TOLEDO - LUCAS COUNTY PLAN COMMISSIONS

REF: SUP-2006-24

TO: President Carrie Hartman and Members of Council, City of Toledo
FROM: Toledo City Plan Commission, Thomas C. Gibbons, Secretary
SUBJECT: Special Use Permit for Scrap & Salvage at 5439 Lewis Avenue

SITE PLAN

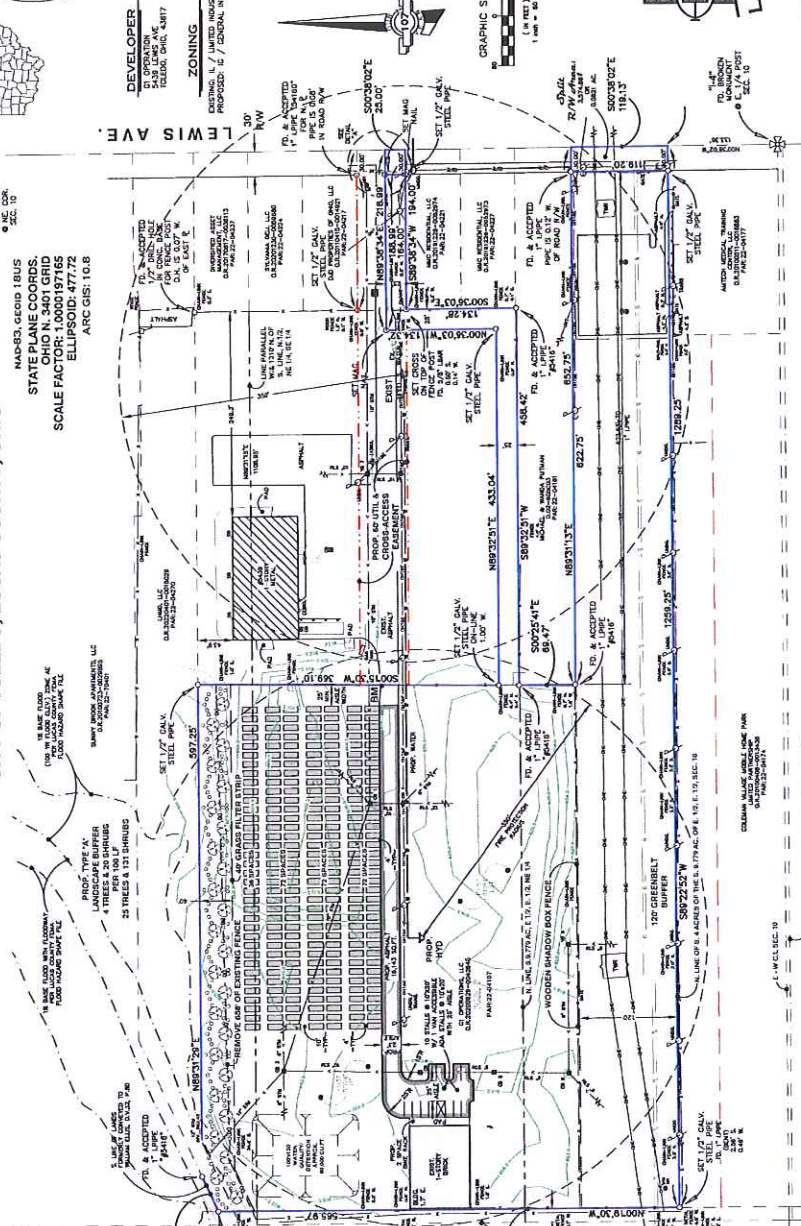
The applicant is proposing to pave the drive aisle and parking area with asphalt, and will seek a variance of TMC§1107.1900 from apply the Board of Zoning Appeals to allow gravel to remain on the rest of the site.

The southern ±120 feet of the site contains an Edison easement with two electrical towers. The site plan depicts this area as a "greenbelt buffer," though no additional landscaping can be added within this space per the easement. If the site plan is approved, the easement shall remain free of all storage related to the scrap & salvage operation.

Per TMC§1108.0202 – *Frontage Greenbelts*, sites over five (5) acres are required to provide a thirty-foot (30') frontage greenbelt and contain at least one (1) tree for every thirty feet (30') of frontage. The property has two (2) frontages on Lewis Avenue for a total of 144'. The northern leg has twenty-five feet (25') of frontage on Lewis Avenue, all of which is driveway. The southern leg is comprised of the Edison easement, as mentioned, and cannot be planted with additional landscaping. The site is unable to meet the requirements of TMC§1108.0202, therefore the applicant shall request a waiver for this requirement.

A Type A Landscape Buffer is required along the northern, southern, and eastern edges of the property where abutting residential uses. This buffer must be ten feet (10') wide and contain four (4) trees and fifteen (15) shrubs with fencing per 100 linear feet. Alternatively, the buffer can exclude fencing if it is twenty-five feet (25') wide with four (4) trees and twenty (20) shrubs per 100 linear feet. Due to the Edison easement and narrow driveway, this requirement can only be implemented along the northern edge of the site. The site plan depicts a forty-foot (40') wide Type A Buffer with 25 trees and 131 shrubs along the northern edge of the site, which is acceptable as depicted. The applicant will request a waiver of the Type A Buffer along the southern and eastern edges of the site.

In addition, a Type B Buffer is required where Industrial Zoning Districts abut Commercial Zoning Districts. This requirement pertains to the southeast of the site where it abuts a CR-Regional Commercial zoning district. A Type B buffer should be comprised of four (4) trees and fifteen (15) shrubs per 100 linear feet. The applicant will request a waiver for this requirement as well, due to the limitations of planting within the Edison easement.

In lieu of the required buffers, the applicant is requesting that the Plan Commission allow the Edison easement to act as a natural buffer between adjacent residential and commercial uses. In addition, the applicant has proposed a fence along the northern edge of the easement to add additional screening for the site. The Planning Director has indicated this would be an acceptable compromise if the Special Use Permit is approved. Fencing materials shall be opaque (either wood or vinyl in an earth tone) and will be subject to final approval from the Planning Director. Additionally, the fence was originally depicted as ending at the western edge of the adjacent parcel with the auto repair shop (#2204181); however, staff requested that this fence be extended along the southern edge of the entire length of the driveway where the subject parcel abuts legal nonconforming duplexes. This fencing will provide screening of the subject site for the mobile home park to the south, the duplexes to the east, as well as the Day Care Center that abuts the site to the southeast. The fence extension is shown on the applicant's revised plan and is acceptable as depicted.

Per TMC§1108.0203(H), outdoor storage screening is required in all Industrial Districts. This code section allows shadow box, chain link with slats, or stockade. The proposed fence will satisfy this requirement along the south and eastern portion of the site; however, the existing chain link fence along the northern edge of the site requires the addition of earth tone slats to screen the properties to the north. This detail shall be included on a revised landscape plan. No

Parking lot landscaping is not required for IG-General Industrial zoning districts unless abutting residential uses. Given the site is surrounded by residential uses, both interior and exterior parking lot landscaping is required. Per TMC§1108.0204(B)(1), twenty (20) square feet of interior landscaping is required per parking space. With eleven (11) parking spaces, the site is required to have 220 square feet of interior landscaping, comprised of two (2) canopy trees and six (6) shrubs (TMC§1108.0204(C)(1)). This landscaping shall be shown on a revised plan.

Perimeter landscaping comprised of one (1) canopy tree per each thirty (30) linear feet, as well as a continuous shrub row, is also required along any parking lot area adjacent to a street, place, or driveway, or which is visible from an immediately adjacent property. This requirement pertains to the eastern edge of the site where there are abutting nonconforming duplexes; however, the narrow driveway prevents any additional landscaping in this area of the site. The applicant shall request a waiver of the five (5) required trees along the ±134' length abutting the duplexes.

Per TMC§1108.0205, interior site landscaping is required in IG-General Industrial districts when they abut a residential use. One (1) 2-inch caliper tree is required for every 2,000 square feet of building coverage, which computes to the need for (4) trees for this site given the building's footprint (±7,344 square feet). Additionally, landscaping is required at all major building entrances. Four (4) trees, as well as plantings along the building's main entrance, shall be shown in a revised landscape plan.

- a. A thirty-foot (30’) frontage greenbelt is required along Lewis Avenue that includes one (1) tree per every thirty feet (30’) of frontage; **Not acceptable as depicted. The site is unable to meet TMC§1108.0202, therefore the applicant shall request a waiver for this requirement.**

- b. A Type A Landscape buffer shall be provided where Industrial Zoning Districts abut residential uses. A Type A Landscape Buffer requires four (4) trees and fifteen (15) shrubs with fencing per 100 linear feet, or four (4) trees and twenty (20) shrubs without fencing; **The site plan depicts a forty-foot (40’) wide Type A Buffer with 25 trees and 131 shrubs along the northern edge of the site, which is acceptable**

- c. A Type B Landscape buffer shall be provided where Industrial Zoning Districts abut Commercial Zoning Districts. Buffer shall include four (4) trees and fifteen (15) shrubs per 100 linear feet; **Applicant shall request a waiver of this requirement. As mentioned in the above condition (b), the proposed fencing along the northern edge of the easement will be extended to provide screening for the Day Care Center, zoned CR-Regional Commercial, that abuts the site to the southeast.**

- d. In all Commercial and Industrial districts, fencing to screen from public view open storage areas shall be required as outlined in TMC§1108.0203(H). Fencing shall be at least six feet (6') in height and be shadow box, chain link with slats, or stockade. **Not acceptable as depicted. Existing chain link fencing along the northern edge of the site requires the addition of earth tone slats to screen the properties to the north. This detail will be included in a revised landscape plan.**

- e. Per TMC§1108.0204(B)(1), twenty (20) square feet of interior landscaping is required per parking space, as the site is abutting residential uses. **Not acceptable as depicted. With eleven (11) parking spaces, the site is required to have 220 square feet of interior landscaping, comprised of two (2) canopy trees and six (6) shrubs (TMC§1108.0204(C)(1)). This landscaping shall be shown on a revised landscape plan.**

- f. Perimeter parking lot landscaping shall be installed along any parking lot area adjacent to a street, place, or driveway and shall be provided abutting the parking area to visually screen all off-street loading facilities from view of public rights-of-way. A continuous shrub with a minimum height of eighteen inches (18") is required; **Not acceptable as depicted. This requirement pertains to the eastern edge of the site where there are abutting nonconforming duplexes; however, the narrow driveway prevents any additional landscaping in this area of the site. The applicant shall request a waiver of the five (5) required trees along the ±134' length abutting the duplexes.**

- g. Per TMC§1108.0205, interior site landscaping is required in IG-General Industrial districts when they abut a residential use. One (1) 2-inch caliper tree is required for every 2,000 square feet of building coverage, which computes to the need for (4) trees for this site given the building's footprint ($\pm 7,344$ square feet). Additionally, landscaping is required at all major building entrances. **Not acceptable as depicted. Four (4) trees, as well as plantings along the building's main entrance, shall be shown in a revised landscape plan.**
